PROPOSED IMPROVEMENT TOWN OF CLARENDON COUNTY OF RUTLAND RUTLAND SOUTHERN VERMONT REGIONAL AIRPORT

RUNWAY 19 SAFETY AREA IMPROVEMENTS PHASE I, TO INCLUDE:

**RECORD DRAWING
DECEMBER 27, 2013**

REPAIRED EXISTING 36" CMP

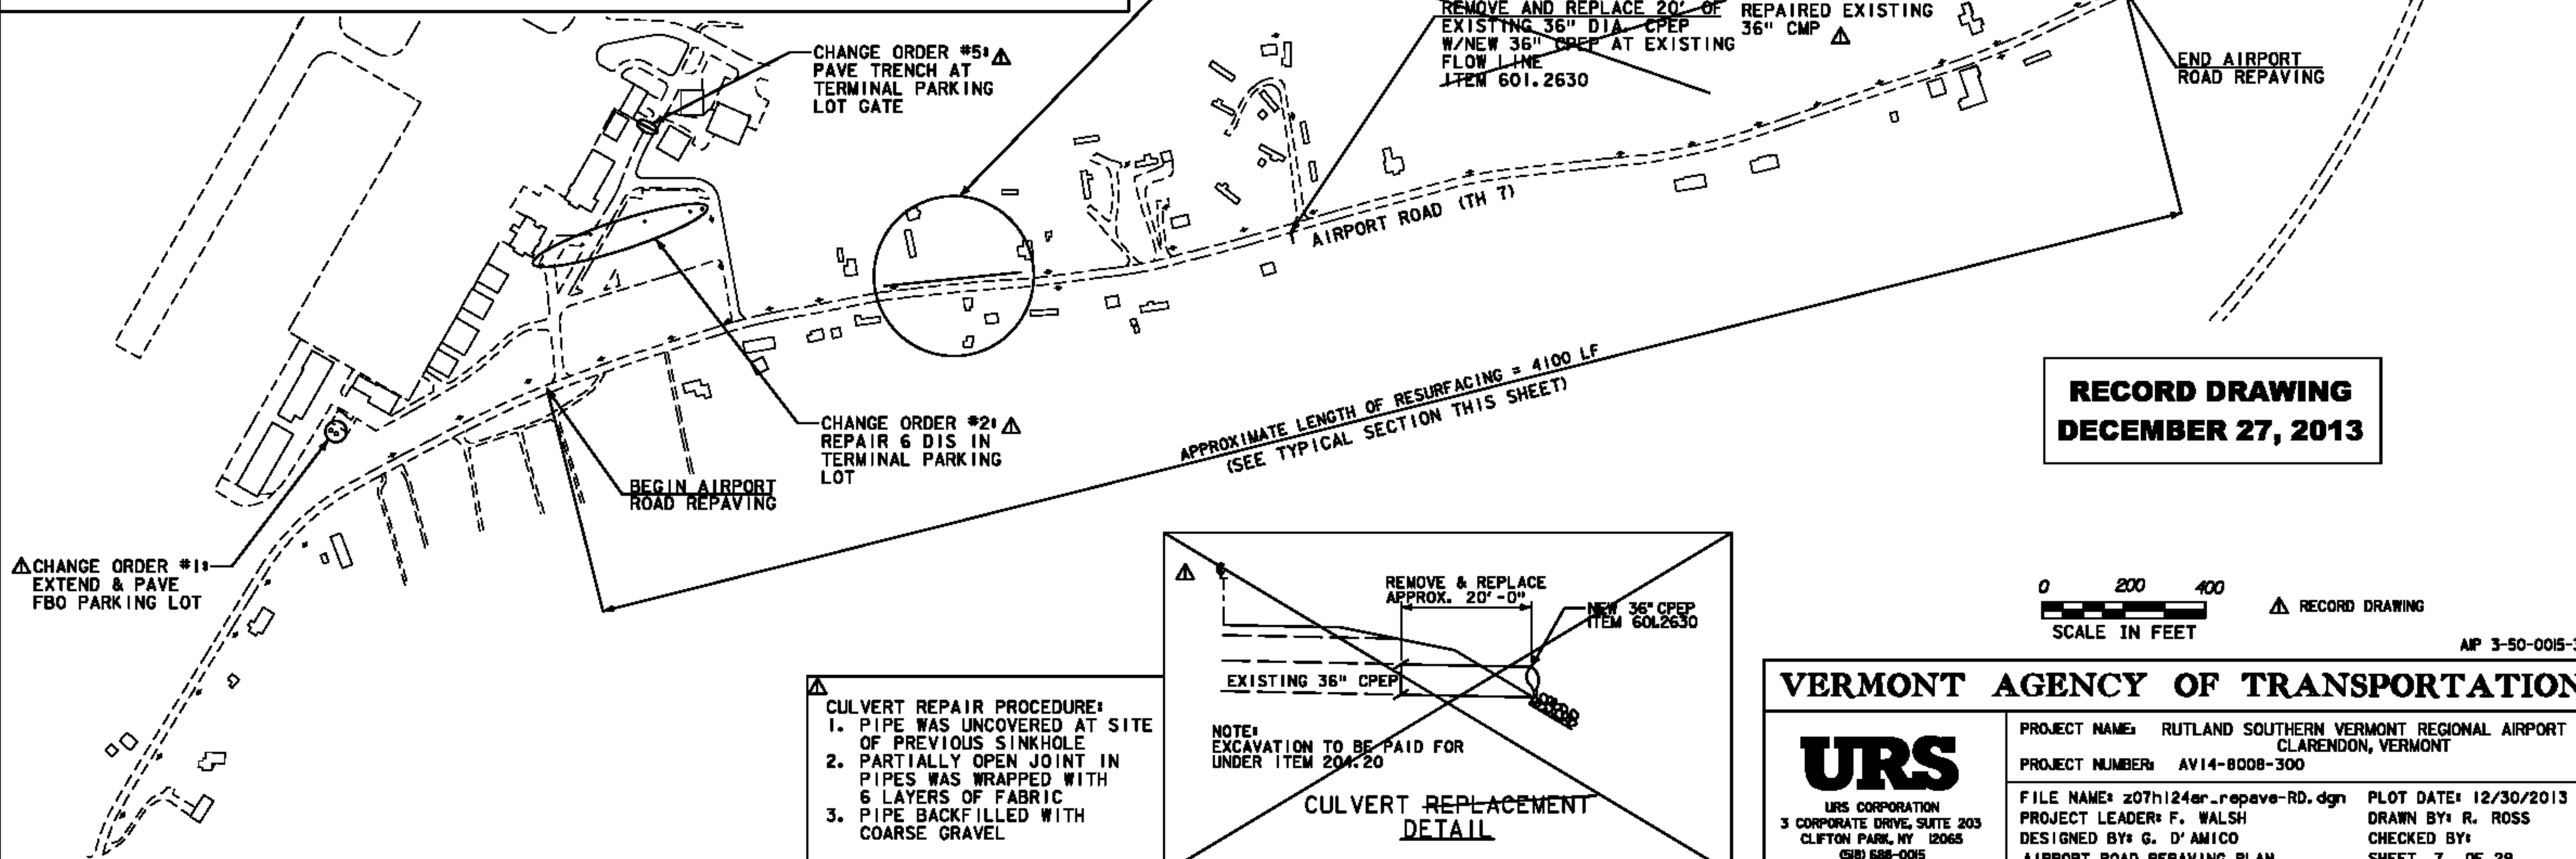
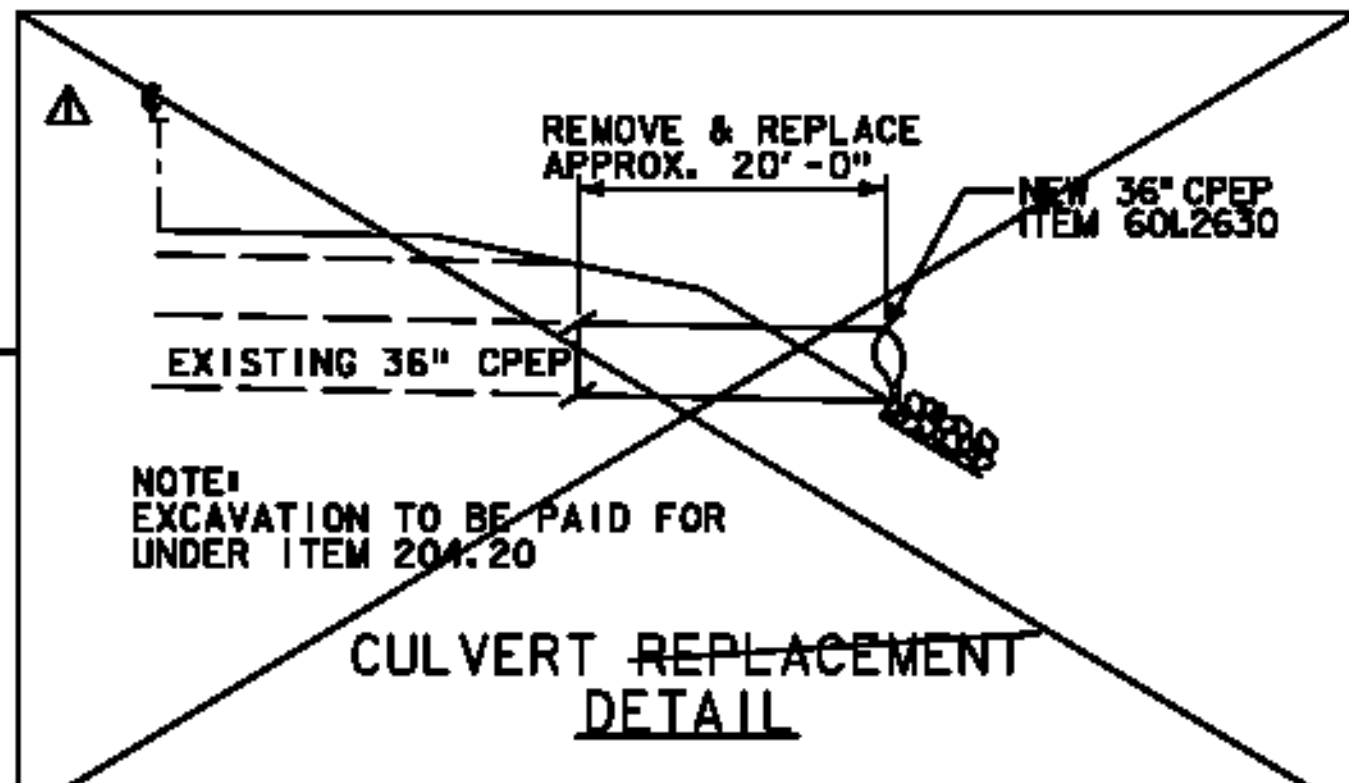
REMOVE AND REPLACE 20' OF EXISTING 36" DIA. CPEP W/NEW 36" CPEP AT EXISTING FLOW LINE ITEM 601.2630

CULVERT REPAIR PROCEDURE:

1. PIPE WAS UNCOVERED AT SITE OF PREVIOUS SINKHOLE
2. PARTIALLY OPEN JOINT IN PIPES WAS WRAPPED WITH 6 LAYERS OF FABRIC
3. PIPE BACKFILLED WITH COARSE GRAVEL

FILE NAME: 207h124drn-RD.dgn
PROJECT LEADER: F. WALSH
DESIGNED BY: G. D'AMICO
DRAINAGE PLAN

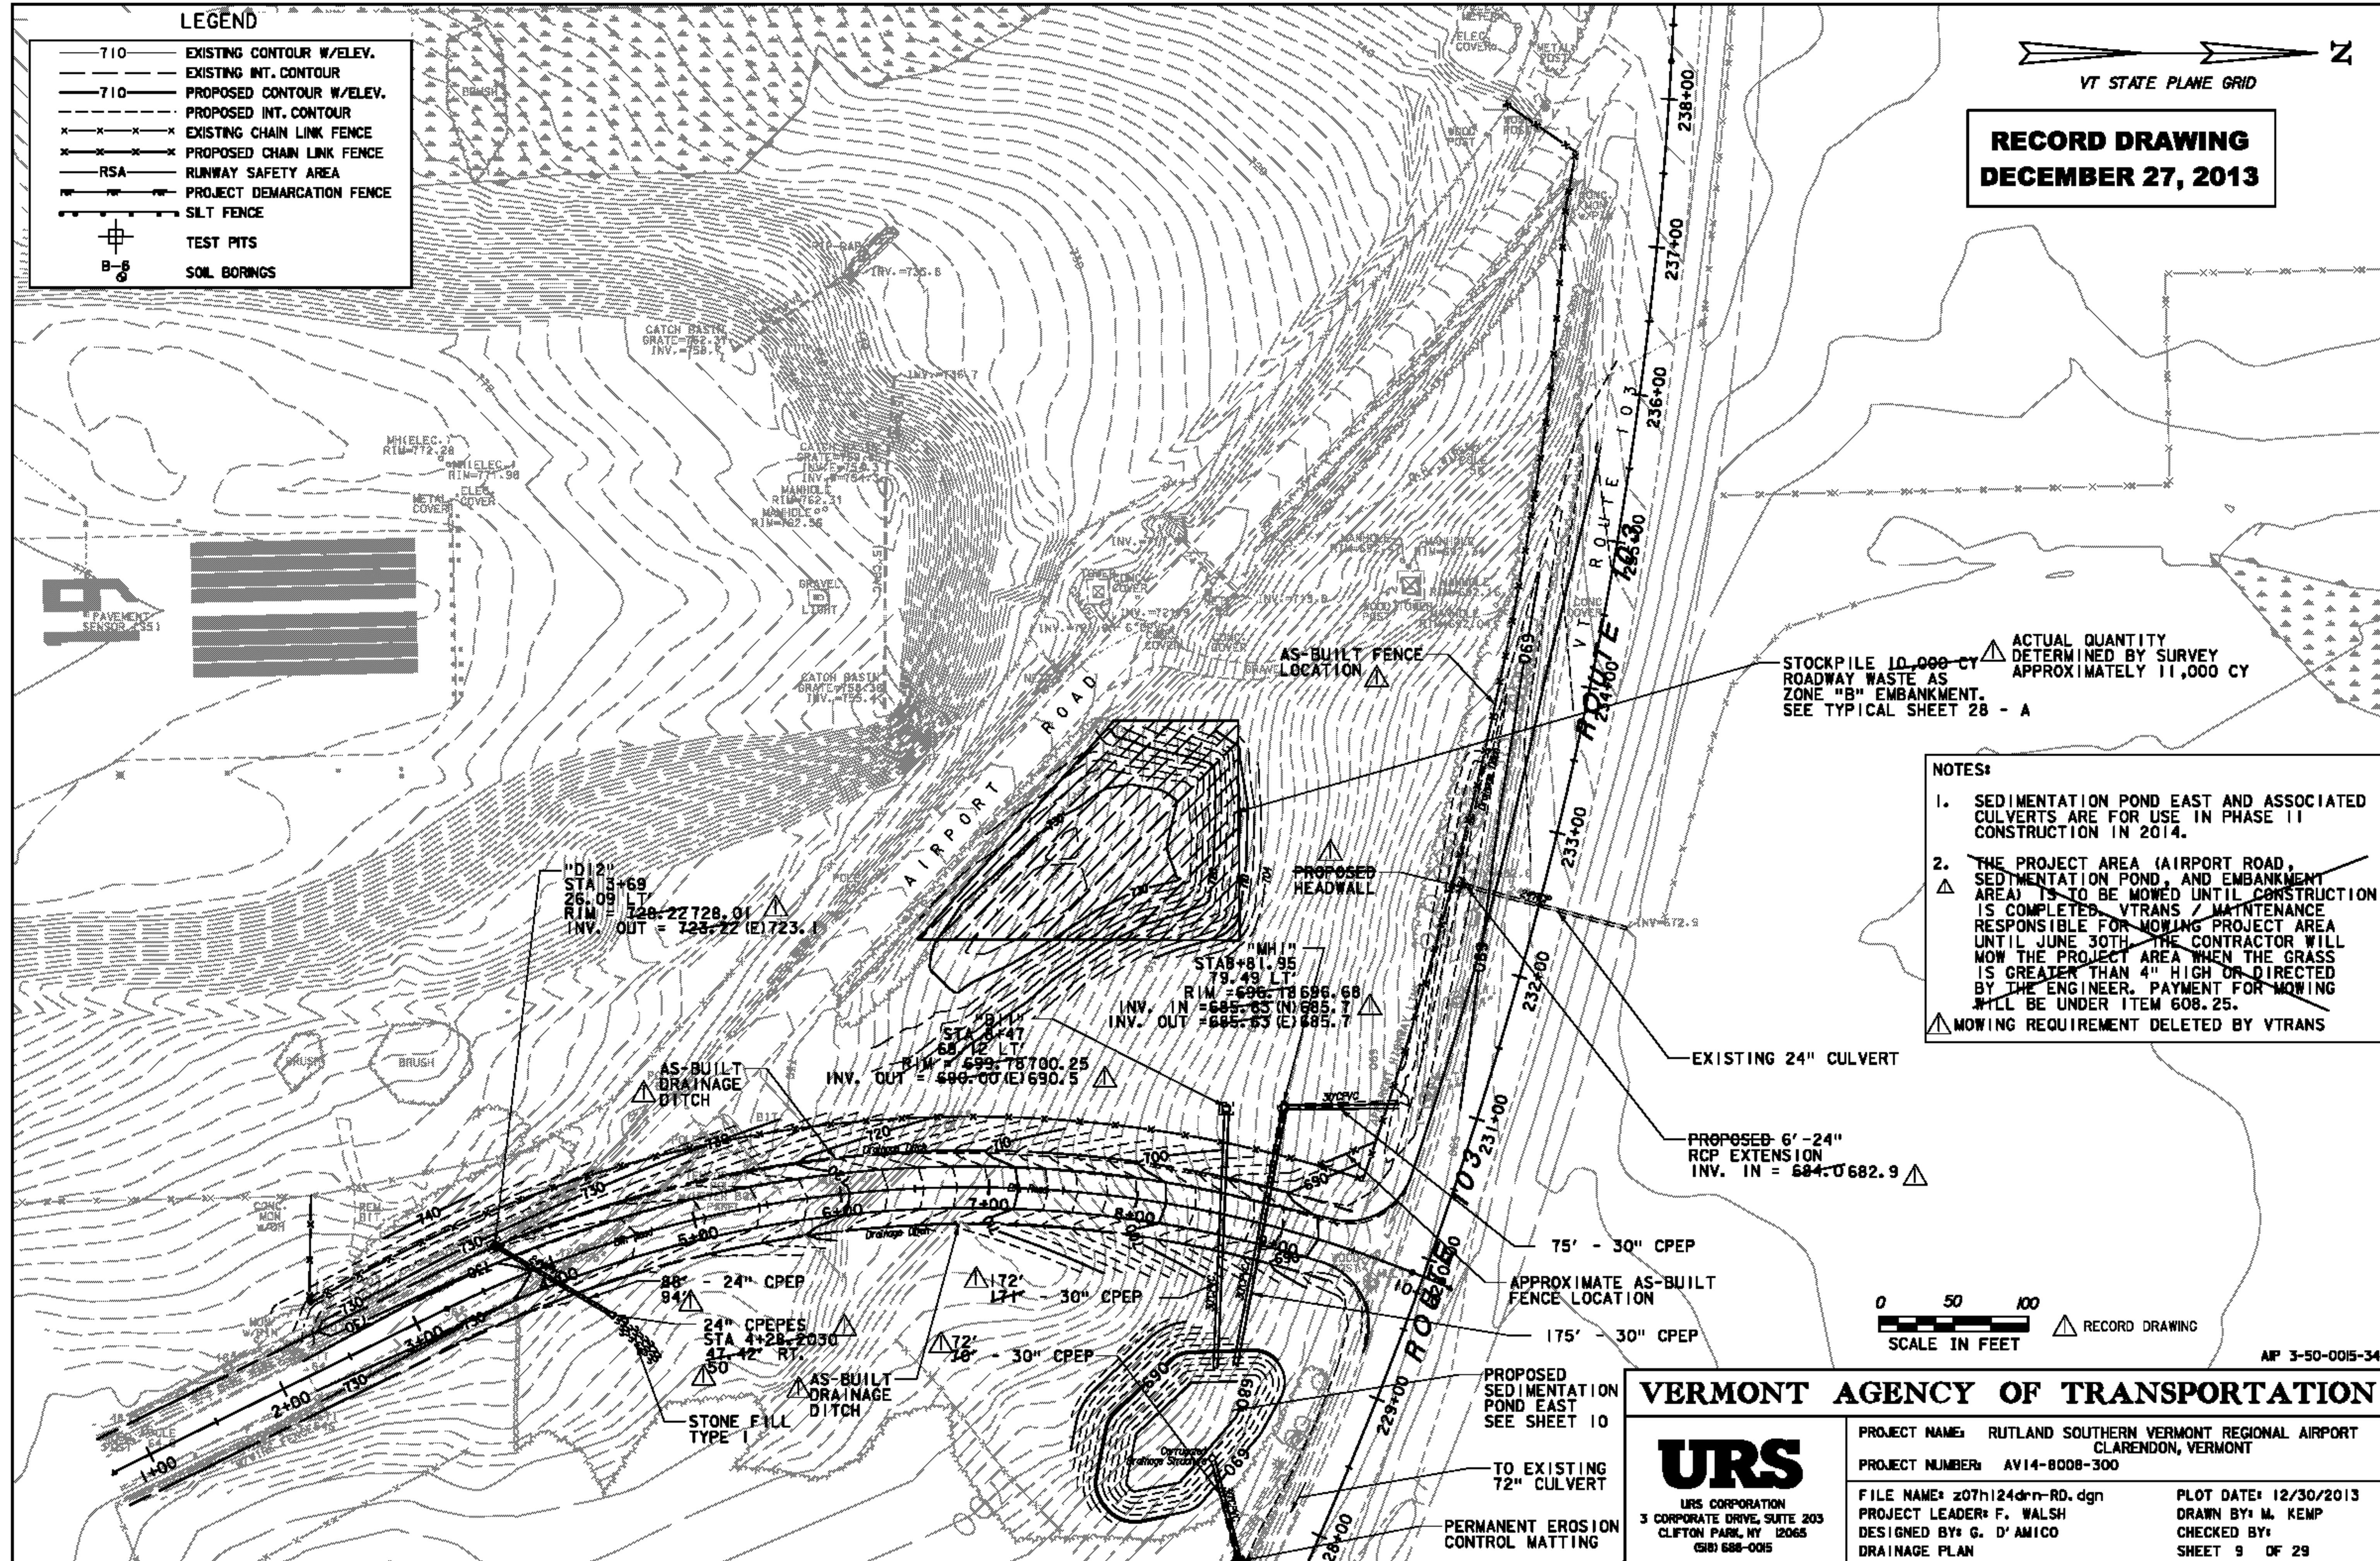
PROPOSED 6'-24" RCP EXTENSION
INV. IN = 684.0682.9 ▲

APPROXIMATE AS-BUILT FENCE LOCATION

"D12"
STA 3+69
RIM = 728.22728.01 ▲
INV. OUT = 728.22 (E) 723.1

"MH1"
STA 8+1.95
RIM = 688.78696.68 ▲
INV. IN = 688.63 (N) 685.1
INV. OUT = 685.63 (E) 685.7

"PB11"
STA 4+47
RIM = 699.78700.25 ▲
INV. OUT = 699.00 (E) 690.5

AS-BUILT DRAINAGE DITCH

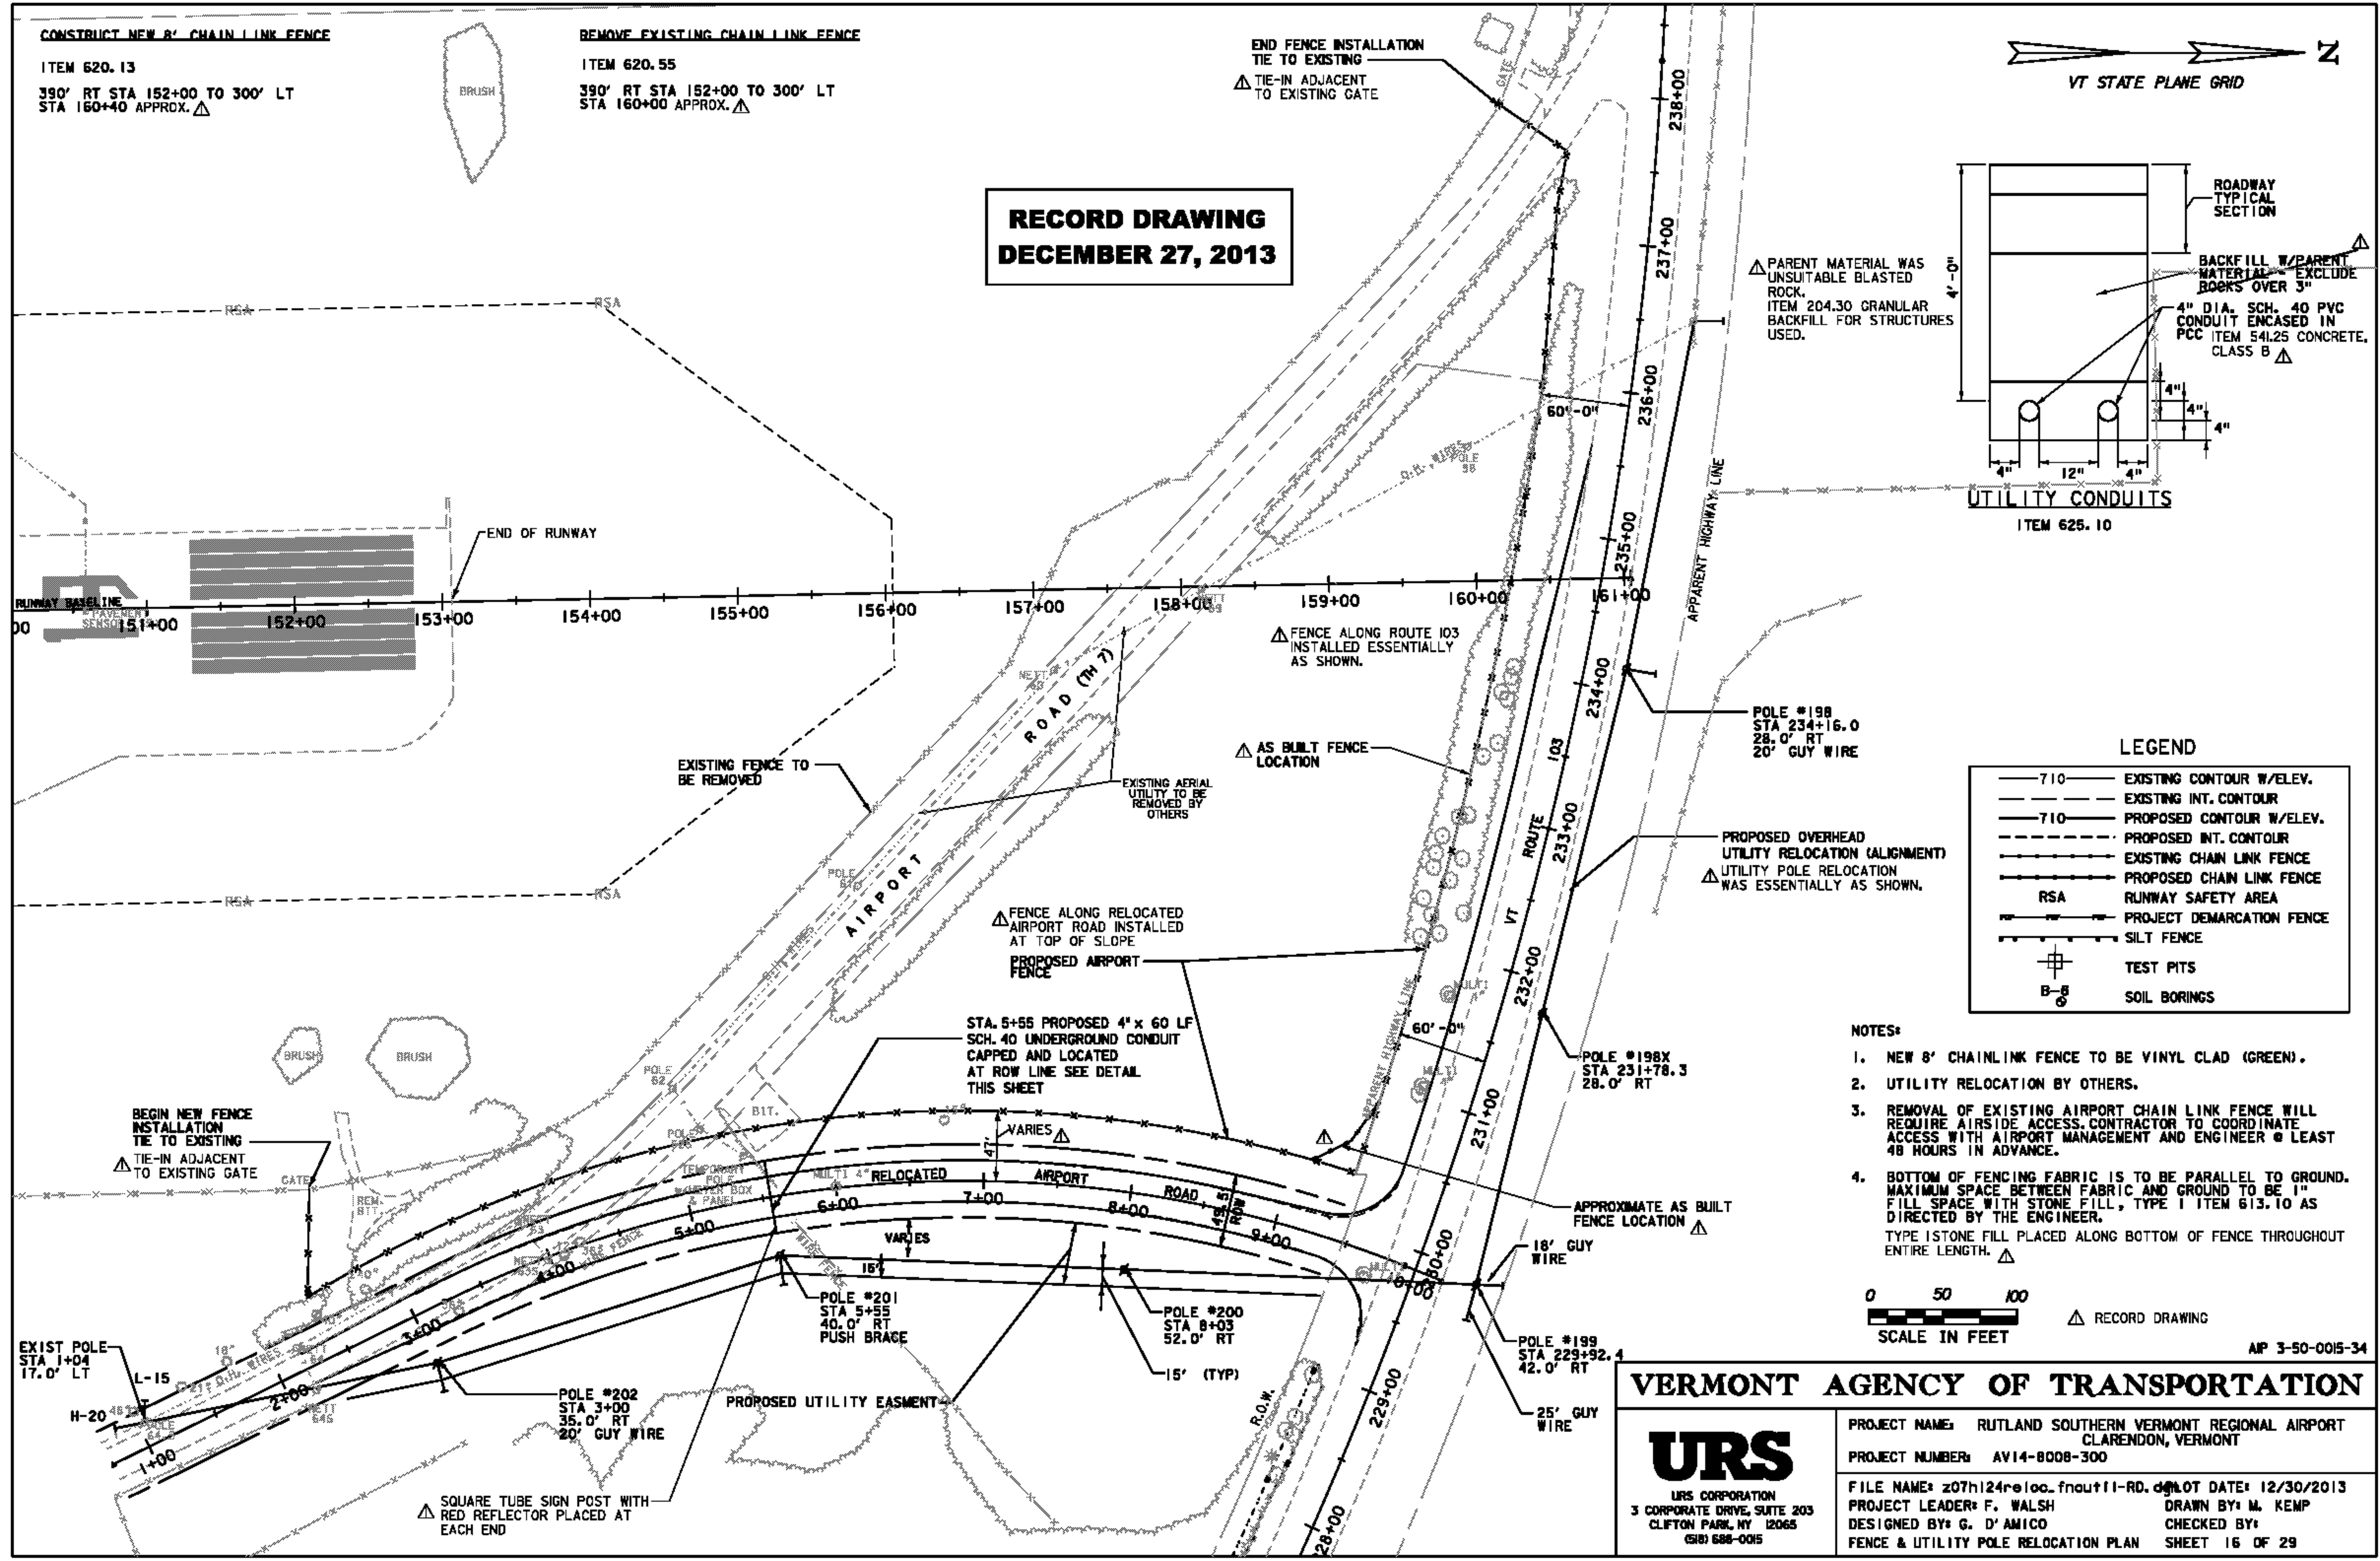
CONSTRUCT NEW 8' CHAIN LINK FENCE
 ITEM 620.13
 390' RT STA 152+00 TO 300' LT
 STA 160+00 APPROX. Δ

REMOVE EXISTING CHAIN LINK FENCE
 ITEM 620.55
 390' RT STA 152+00 TO 300' LT
 STA 160+00 APPROX. Δ

END FENCE INSTALLATION
 TIE TO EXISTING
 Δ TIE-IN ADJACENT
 TO EXISTING GATE
